Glenellen Solar Farm Amendment Report

Glenellen Solar Farm Pty Ltd

Project Name	Glenellen Solar Farm Amendment Report
Project Number	600-20COF15523
Project Manager	Daniel Magdi
Prepared by	Daniel Magdi, Rebecca Ben-Haim, Konrad Grinlaubs, Sam Oomens
Reviewed by	Rachel Murray
Approved by	Rachel Murray
Status	Final
Version Number	V3
Last saved on	14 December 2022

Figure 3: Amended Project Footprint

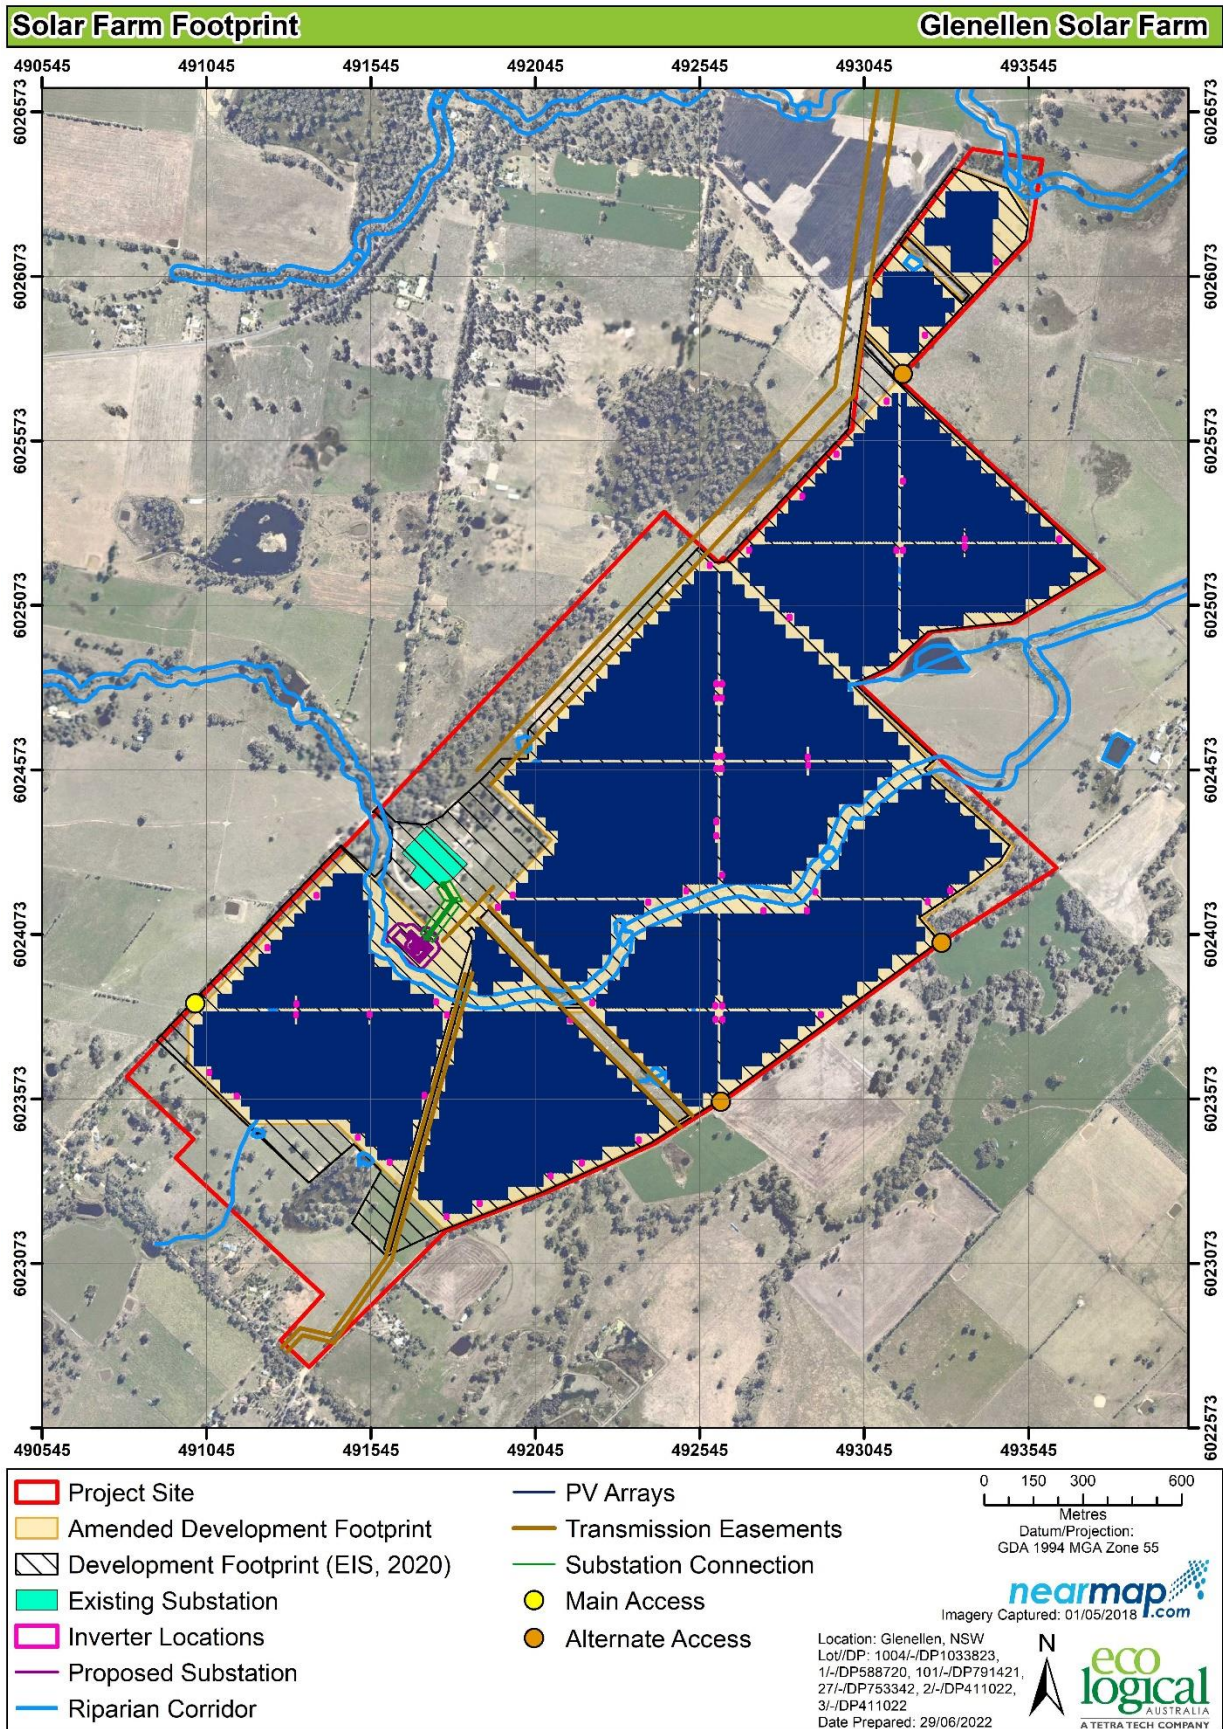
The Project amendments are illustrated in Figure 3 and summarised in Table 4. A consolidated Project Description is provided in Appendix A.

The Project Site remains unchanged from the lodgement of the EIS (ELA 2020), however there have been several changes to the Project Site. The impacts from the Project have reduced from 334.2 ha as outlined within the EIS (ELA 2020) to 308.9 ha under the amended Project description, refer to Figure 3 above and Appendix A for more details.

Figure 4: Cross-section of Project Substation

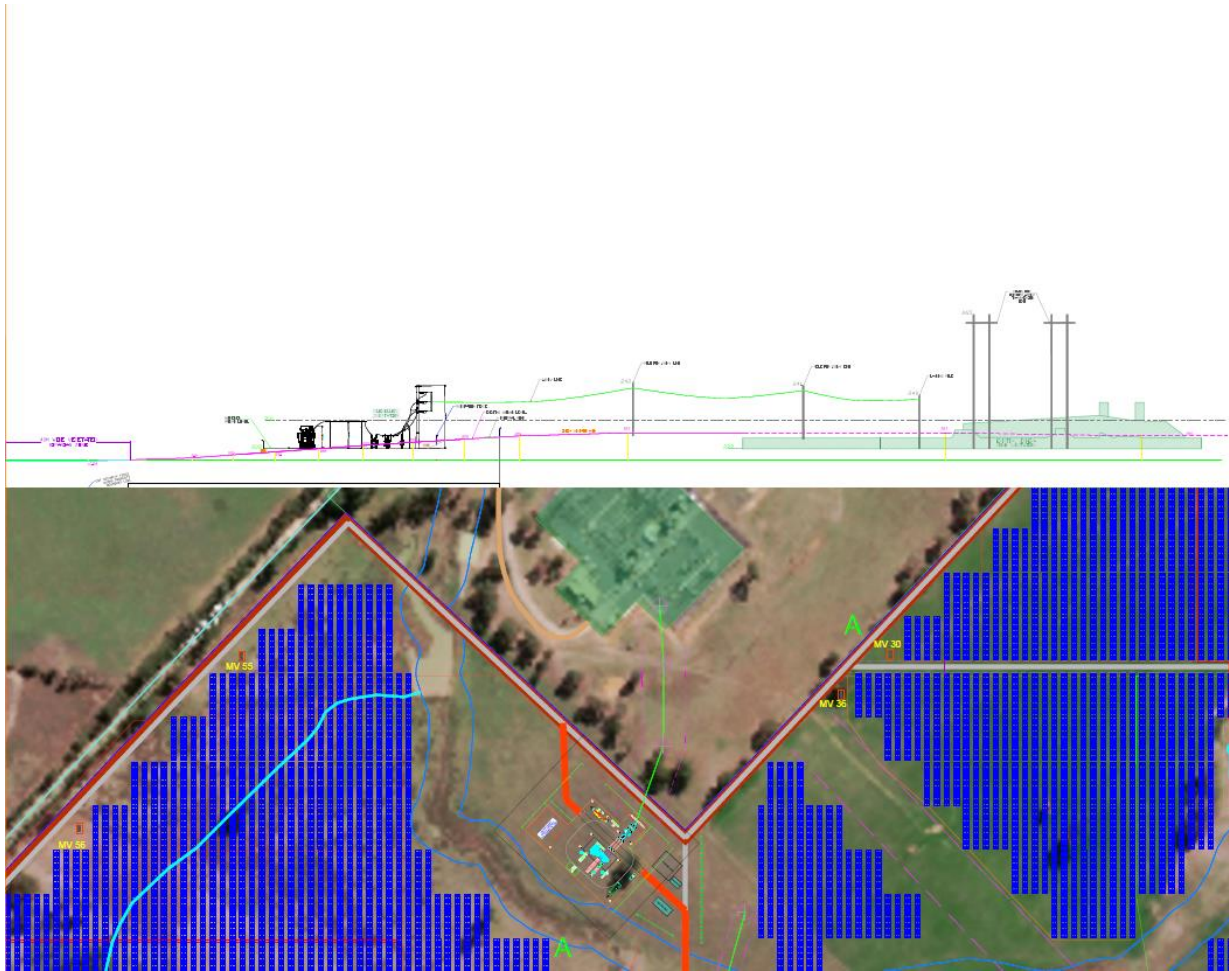
The proposed grid connection infrastructure is an expansion to the existing 330/132/22kV Jindera Zone Substation located adjacent to the Project Site. The location of the Project Substation with the EIS (ELA 2020) was to the south-west of the existing TransGrid Jindera Zone Substation, running in parallel to the existing 132KV overhead lines. Whilst considering feedback from the submissions on the EIS and after further consultation with TransGrid, the Project Substation has been relocated to the south of the existing TransGrid Jindera Zone Substation (Figure 3).

Furthermore, the Project Substation has been designed so that it will have a profile that is lower than the existing Jindera Zone Substation. The Project Substation will be cut into the existing contour profile, approximately 3 m and has been designed so that is still above the 1:100 flood event levels. To further minimise and potential visual or noise impacts, strategic vegetation screening will be undertaken the east and south will remove all direct views from neighbours. A cross-section of the Project Substation has been provided in Figure 4.

Figure 6: Ortlipp Road Setback cross-section

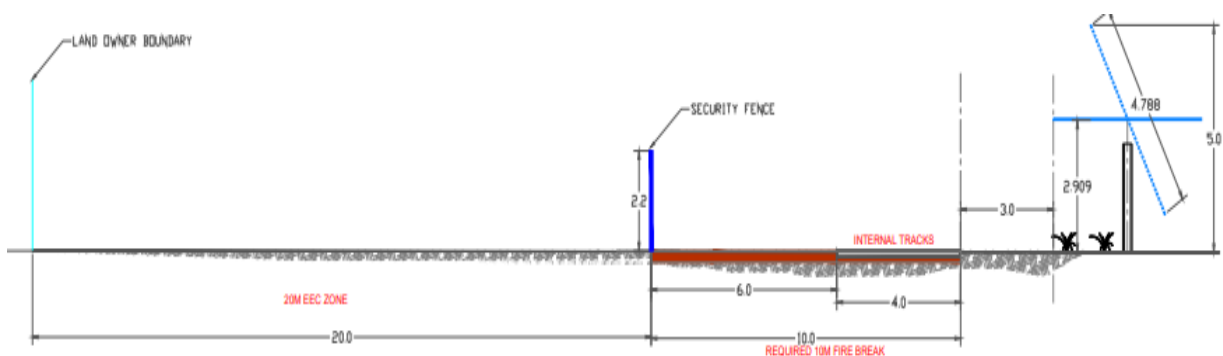
The Project setback along Ortlipp Road has been increased from 10 m to 30 m to reduce impacts upon native vegetation along Ortlipp Road. The setback contains a 20 m wide corridor containing native vegetation, then the security fence, then a 10 m wide corridor which contains the APZ and perimeter access track (Figure 6). The mapped native vegetation along Ortlipp Road is Blakely's Red Gum - Yellow Box grassy tall woodland of the NSW South Western Slopes Bioregion which is listed as a Critically Endangered Ecological Community (CEEC) listed under the NSW *Biodiversity Conservation Act 2016* (BC Act).

Figure 7: Drumwood Road Setback cross-section

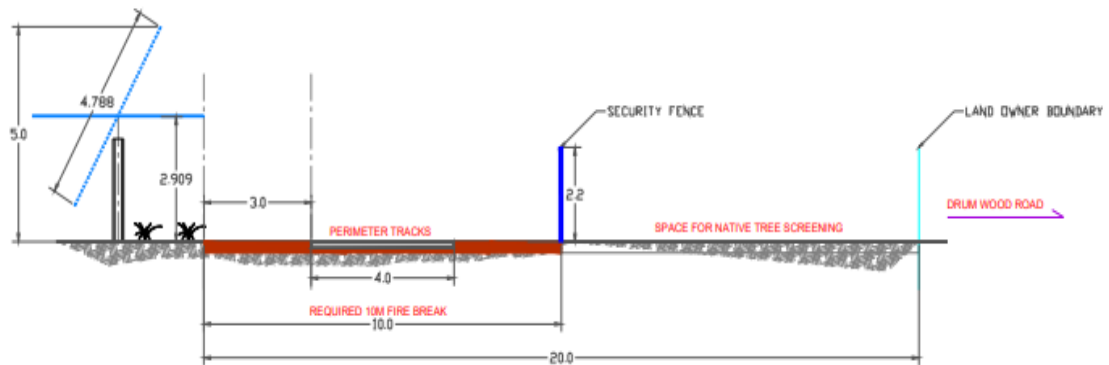
The Project setback along Drumwood Road has been increased from 10 m to 20 m to allow for a 10 m wide screening corridor. The setback contains a 10 m wide corridor for vegetation screening, then the security fence, then a 10 m wide corridor which contains the APZ and perimeter access track (Figure 7).

Figure 8: Re-contouring Plan

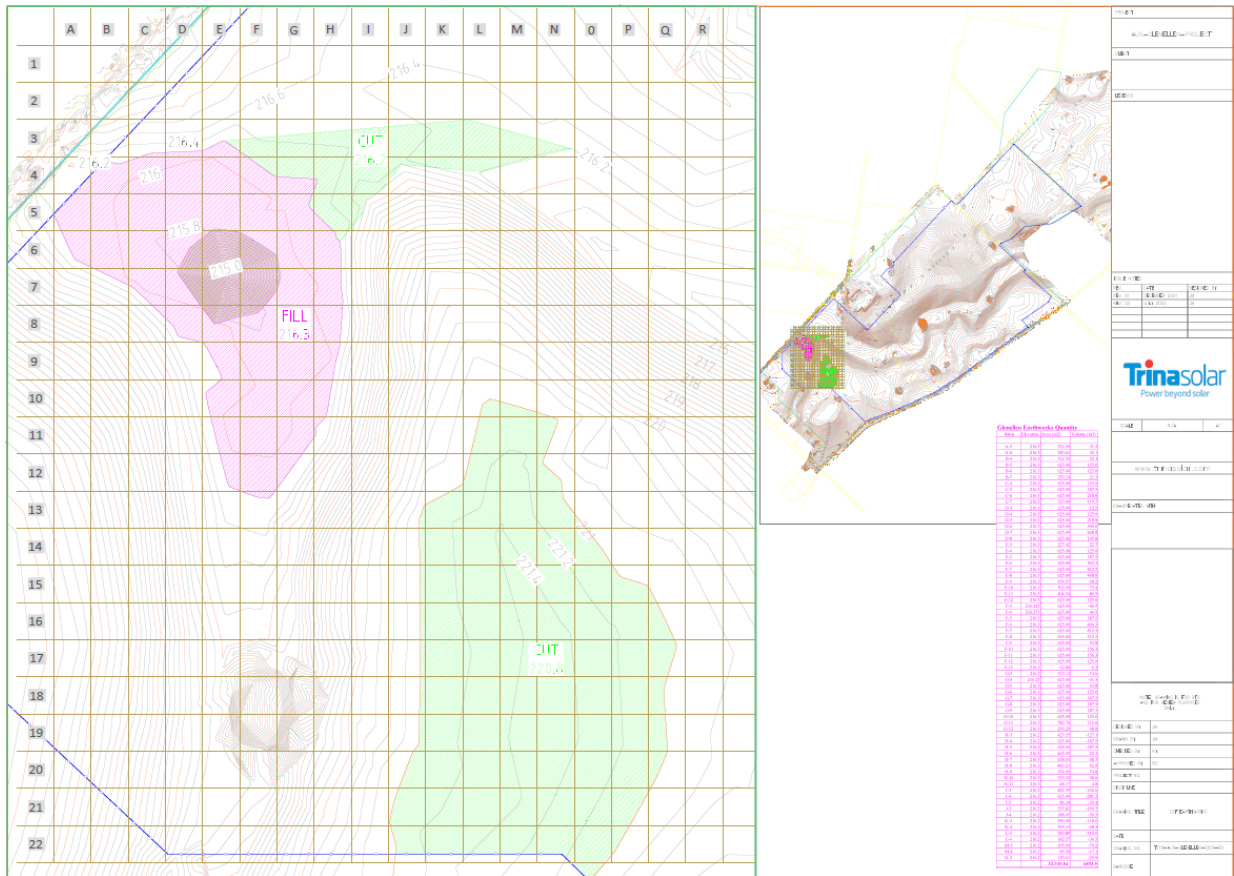
In addressing public comments received upon drainage impacts upon neighbouring properties and agricultural land, the Proponent investigated a number of potential amendments to the Project design. One amendment to the Project Design has been the re-contouring of an inundation area in the south-eastern part of the Project Site to allow for natural flows to occur, and prevent any backfilling inundation into adjacent properties and agricultural land. The inundation area is located along 2nd Order stream adjacent to Ortlipp Road.

The re-contouring will be undertaken through via cut and fill, with Figure 8 illustrating the cut areas in green and the fill areas in pink.

Figure 12: Impact comparison

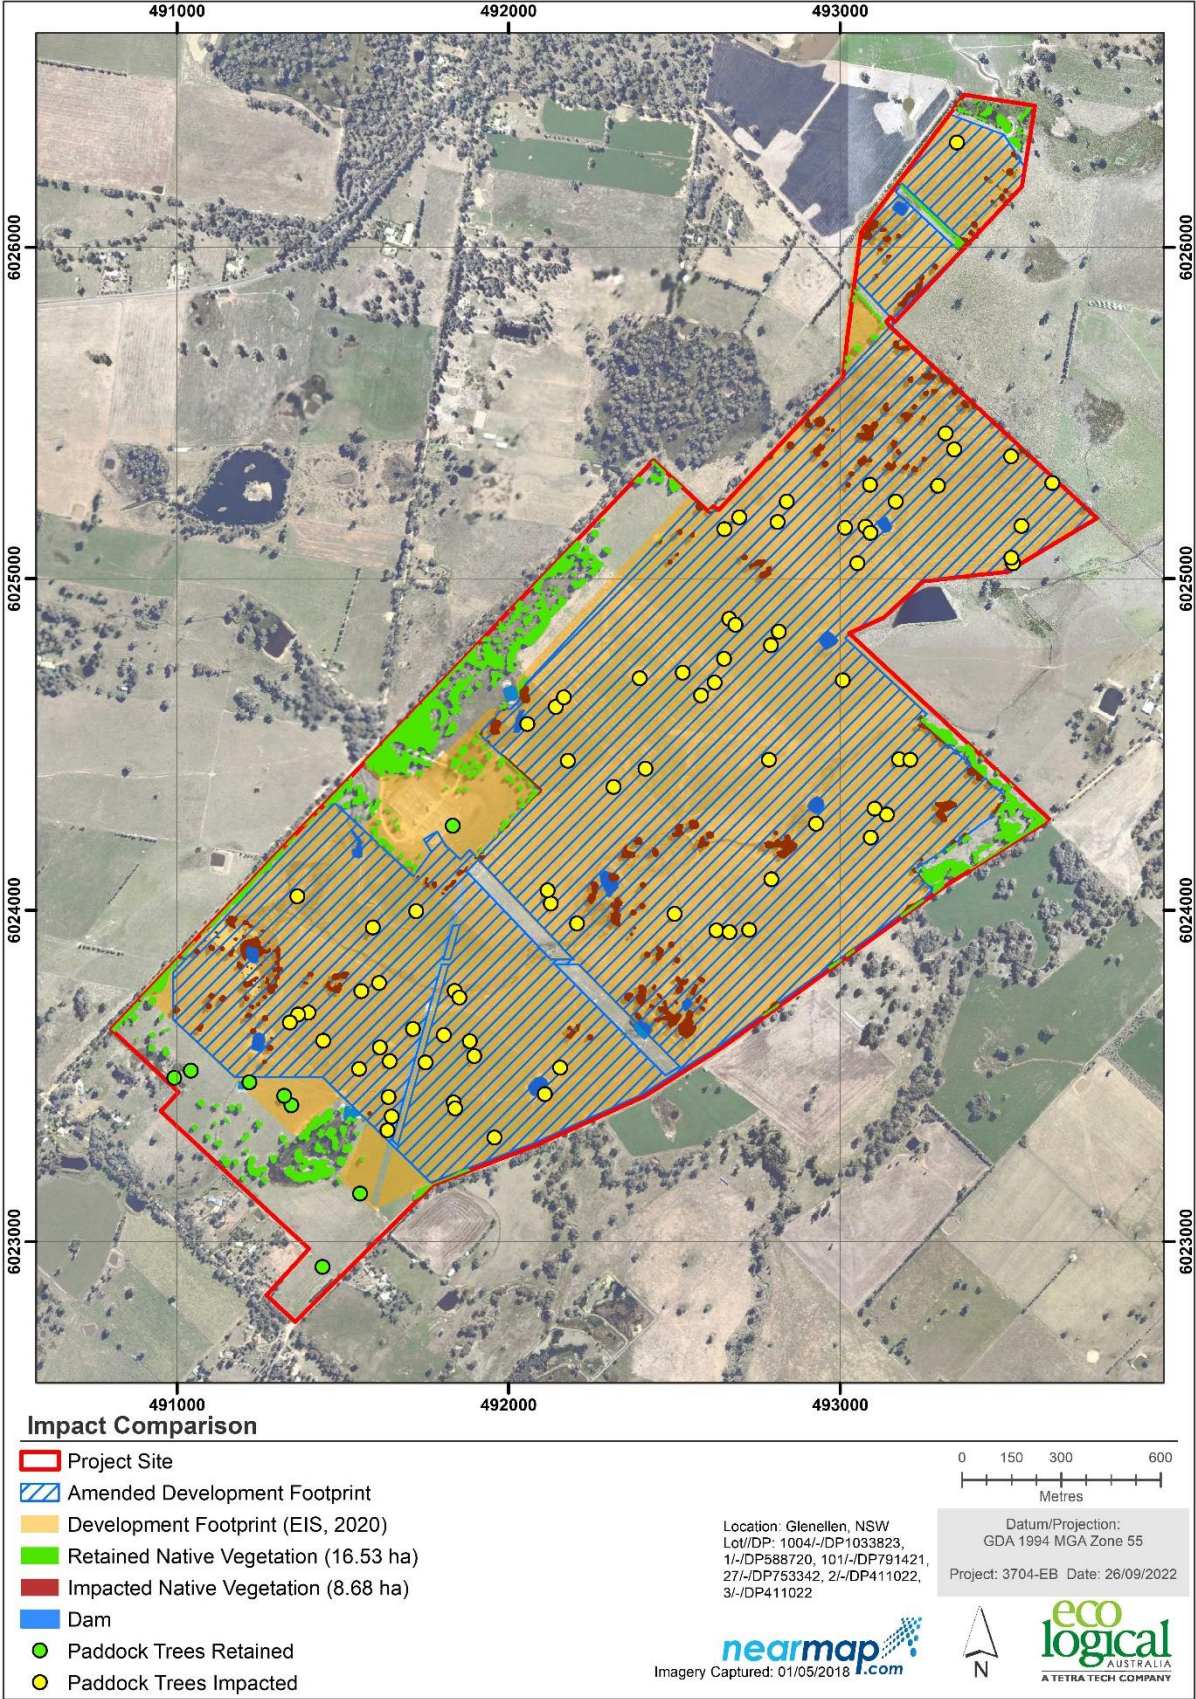
The Project has been located in a way which avoids and minimises impacts (Table 12). The Project Site has been highly modified through historical clearing and grazing which is reflected by the low biodiversity values within the Project Site. Direct impacts including the final Project footprint (construction and operation) are shown in Figure 3, with a comparison of impacted (8.6 ha) and retained (11.4 ha) native vegetation within the Project Site shown in Figure 12.
